DEVELOPMENT HEARING OFFICER

PR-2022-006568

SD-2023-00147 - REHEARING OF PRELIMINARY PLAT

Project Name: 9200 Wilshire Subdivision

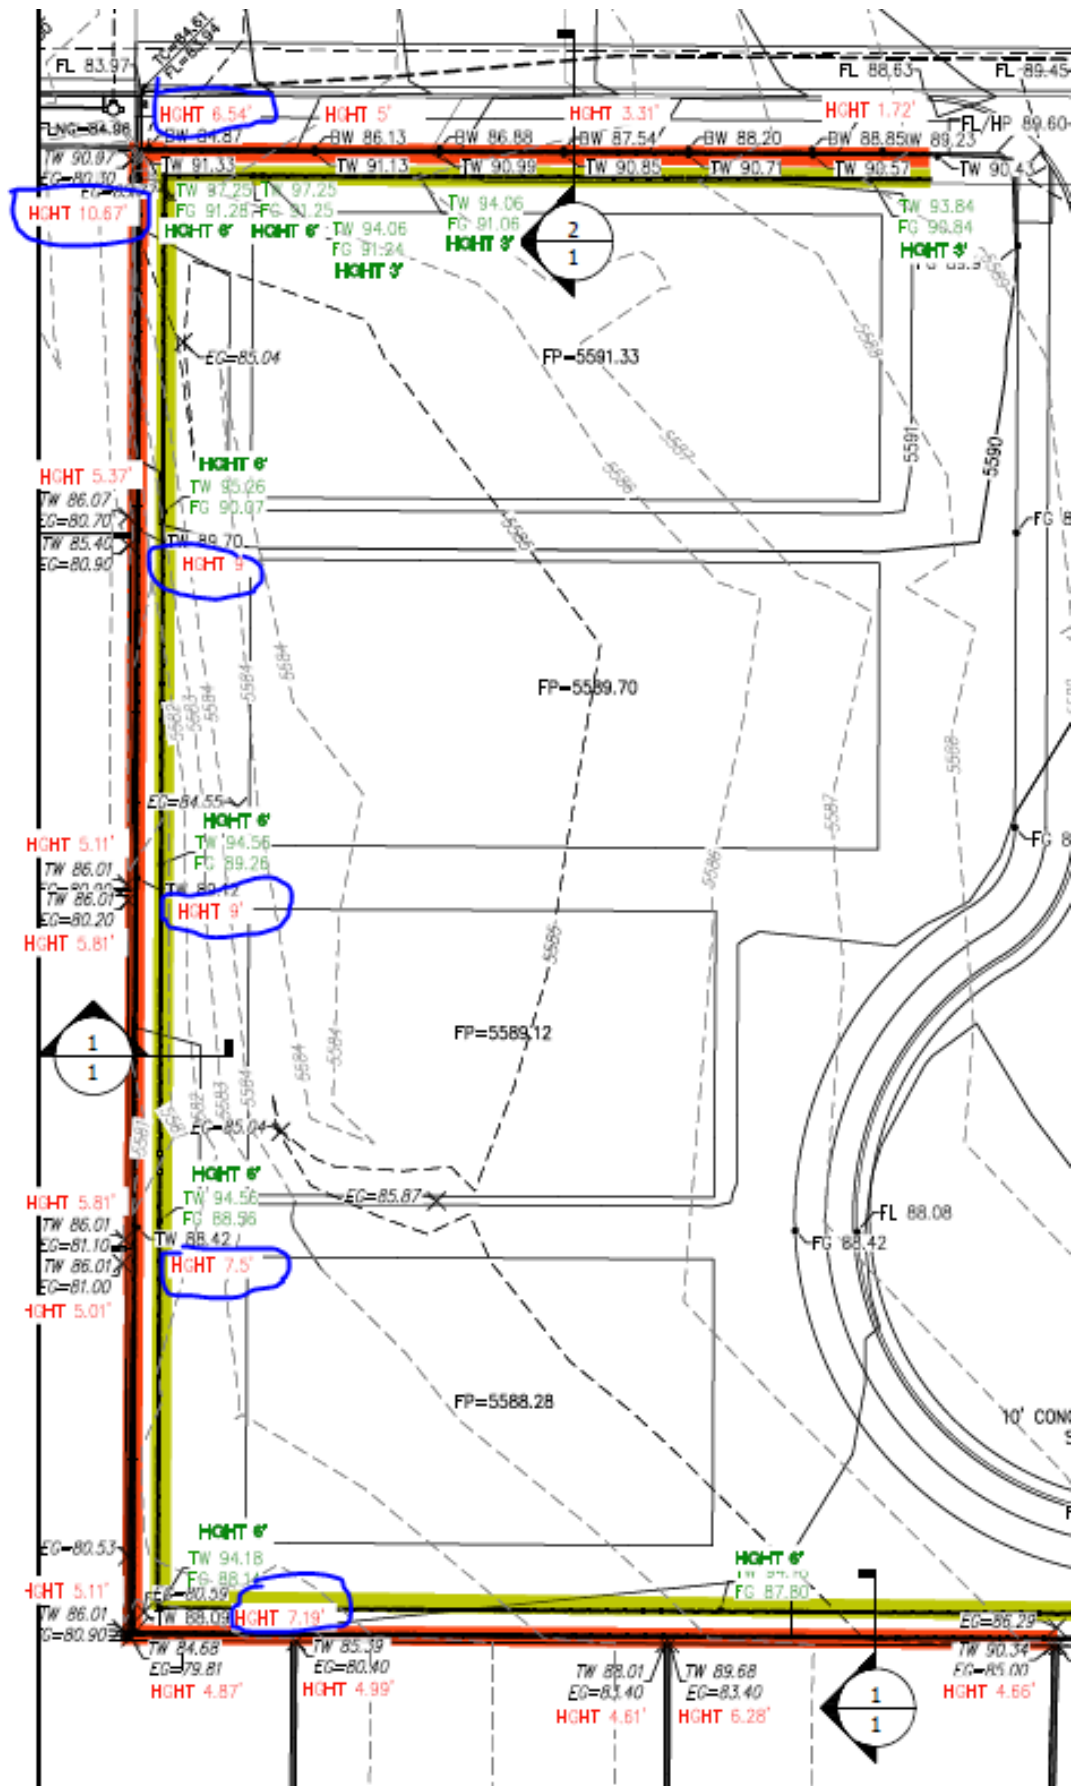
Deferral recommended: The case is recommended for deferral because the wall exhibits remain unclear and new information is now being show for retaining walls taller than 6 feet which were not shown on previous submittals. (More discussion on wall heights follows.)

- The subdivision grading plan with height of fill remains out of compliance with IDO 5-4(J)(1)(b) below.

5-4(J)(1)(b) New subdivisions shall blend development into the adjacent environment with a minimum of grade change. Extensive fill that raises the grade for proposed lots at the edge of a proposed subdivision above the grade of nearby property shall be avoided. Significant cuts near the edges of a proposed subdivision to lower the grade within the development shall be avoided.

The Exhibit below is from the Applicant's original and current submittals and shows a range from 0 to 6 feet for retaining walls. The actual height shown in resubmittals reveals that the retaining walls were planned in many locations to range from 7.19-10.67 feet.

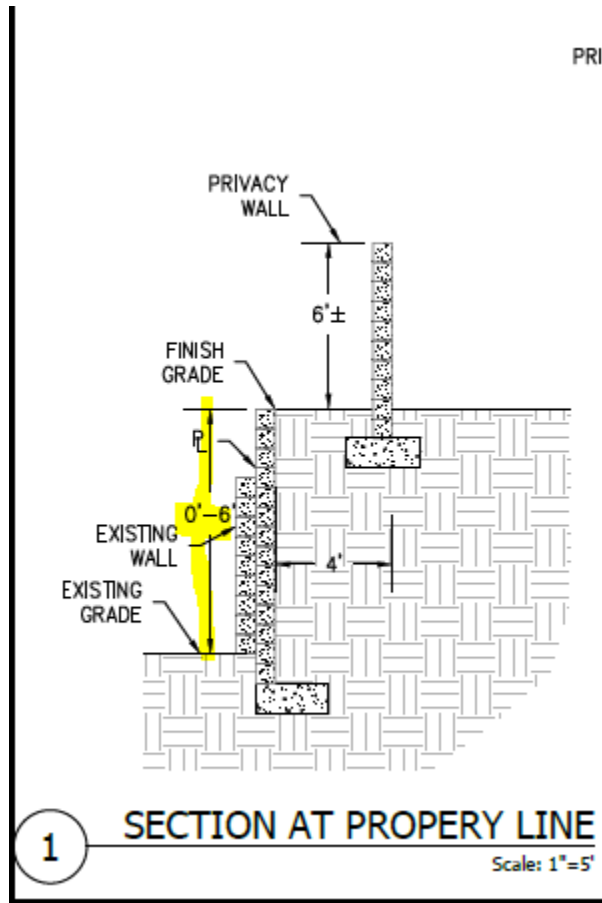
- 1) A retaining wall height of 10.67 feet is shown on the northwest property line. The previous figure for the Wall Figure #1 shows a range of 0-6 feet. The original submittal provided information that was erroneous. Per IDO 5-7(F)(1)(b) a retaining wall higher than 6 feet shall be terraced. (see cite below). Applicant must redo this retaining wall design to meet the IDO.
- 2) Other retaining walls of 7.19, 7.5 and 9 feet are shown on the west property line, extending to the south lot. The previous figure for the Wall Figure #1 shows a range of 0-6 feet. The original submittal provided information that was erroneous. Per IDO 5-7(F)(1)(b) a retaining wall higher than 6 feet shall be terraced. (see cite below). Applicant must redo this retaining wall design to meet the IDO.

- 3) Clarification is needed for the wall in 'butterscotch' color below. The retaining portion of these walls cannot be taller than 6 feet without a terrace.
- 4) The applicant had previously shown a stacked wall, see Wall height #3 along the eastern portion of Wilshire. This wall was not in compliance with the IDO for wall height along the street-facing front or side yard. The applicant has made modifications so that the retaining wall and privacy wall are not separated by a terrace, bringing these wall sections into compliance.
